**From:** "Paul Gunter" <pgunter@nirs.org>  
**To:** <hga@nrc.gov>  
**Date:** 07/26/2006 4:19:11 PM  
**Subject:** RE: letter on Oyster Creek embedded drywell liner

Please find the attached memorandum dated July 26, 2006 from Dr. Rudolf Hausler of Corro-Consulta. It regards the age management review of inaccessible and embedded regions of the Oyster Creek drywell liner and other General Electric Mark I Boiling Water Reactors. Dr. Hausler is identified as our corrosion expert in support of an Atomic Safety Licensing Board (ASLB) hearing on the contention regarding the age management review of severe corrosion of the all important containment component at Oyster Creek nuclear generating station in Lacey Township, New Jersey.

**Memorandum**

**Subject:** Oyster Creek, Drywell Liner  
Embedded Region Issues

**Schematic Drawing of Lower Spherical Section of Drywell Liner**  
(not to size)

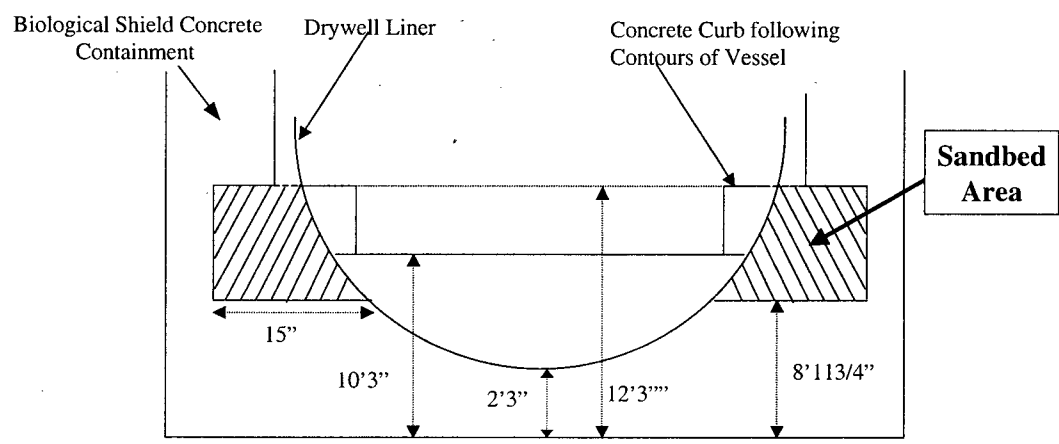
Figures 1 and 2 are sketches of the location of the sandbed area and its dimensions (Fig. 2). In view of the small access hole (20" diameter) and the even smaller sandbed dimensions (15" wide) and the resulting very confined work area one needs to wonder just how effective the repairs of the concrete floor and subsequent coating and sealing of the crevice might have been. Similarly, considering the extension of the sandbed area of 5 to 7 feet either side of the access hole, and its narrowness, one needs to ask just how thorough visual inspection can really be.

**Formation of Crevice underneath Screw-head**

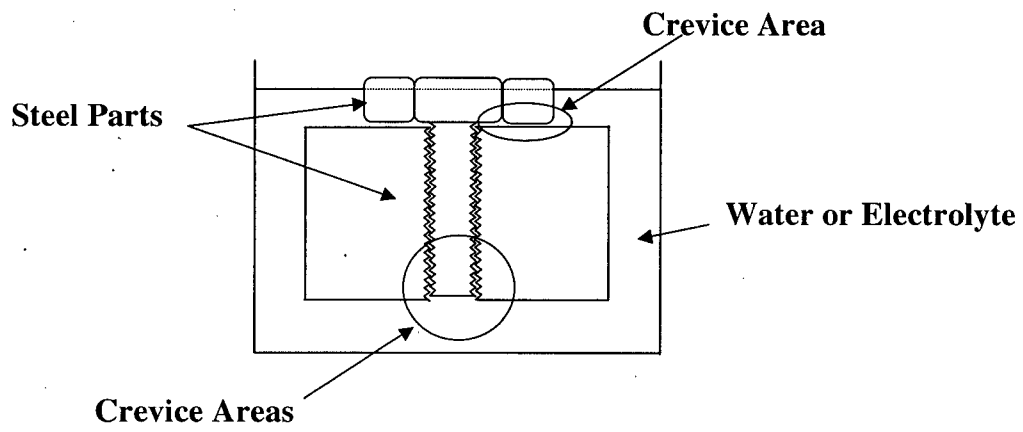
The differential aeration cell consists of a piece of iron of which one part is in contact with aerated water (or solution) while the other part is in contact with deaerated water. This situation can occur in various ways. For instance a bolt screwed into a piece of iron (Fig. AI-1) can create a crevice underneath the bolt head or in the threads where water can seep in. Another example might be a ground rod sticking into mud or indeed a metal plate in contact with wetted sand. In all these instances part of the metal is in contact with water containing oxygen (fully aerated) and metal where oxygen has difficulties to get to.
